PRODUCT/PROCESS CHANGE NOTIFICATION

PCN APG-ABD/14/8514
Dated 06 Jun 2014

**Matrix lead-frame: Additional lead-frame option
implementation on VIPower products housed in DPAK package**

DPAK FRAME COMPARISON

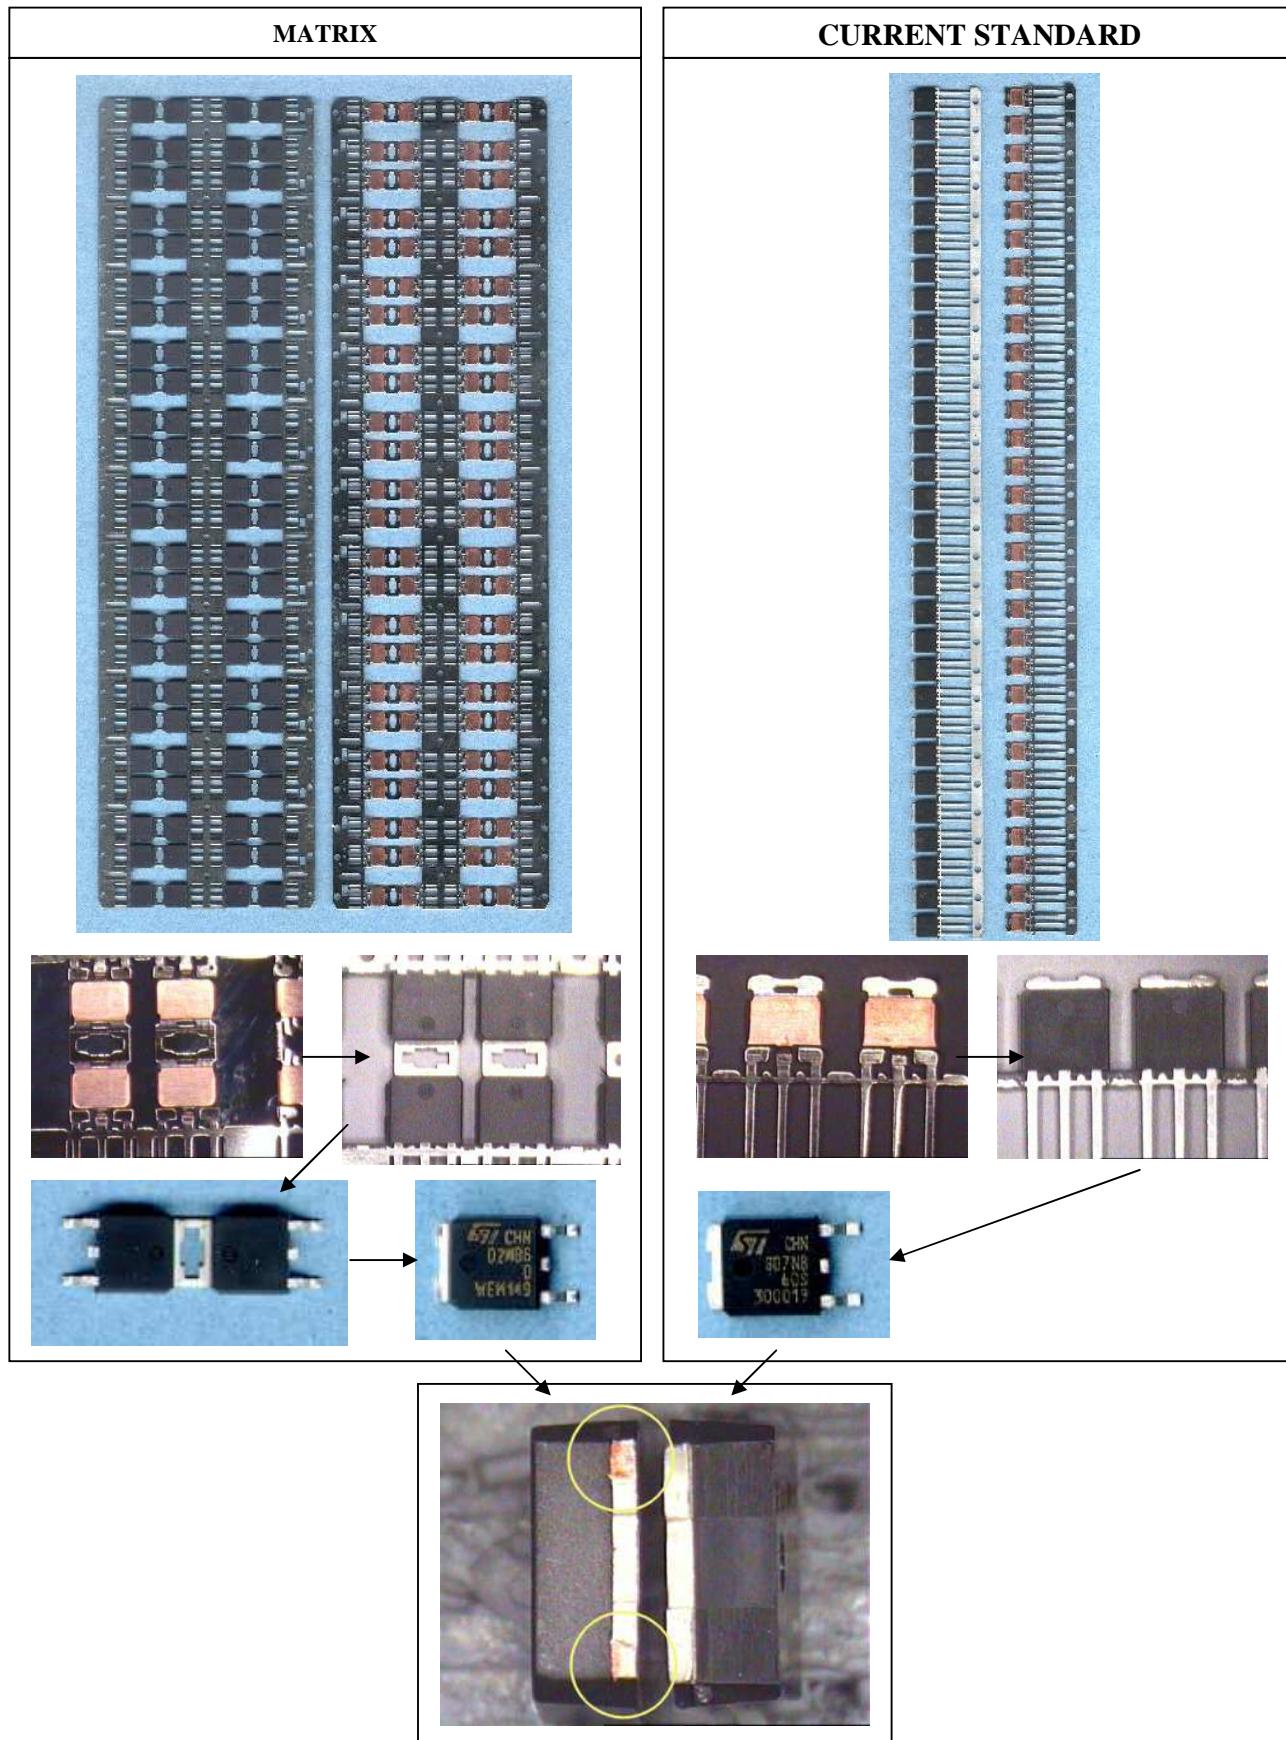
We are going to implement the matrix lead-frame on VIPower products housed in DPAK package as additional lead-frame option. No other material have been changed.

Item	Current	New
Molding Compound	SUMITOMO EME7026	SUMITOMO EME7026
Die Attach	Preform Pb/Ag/Sn	Preform Pb/Ag/Sn
Bonding wire	Al 7 mils, 10 mils	Al 7 mils, 10 mils
LeadFrame	Standard	Matrix
Lead-plating	Sn 100%	Sn 100%

See enclosed qualification plan and lead-frames comparison
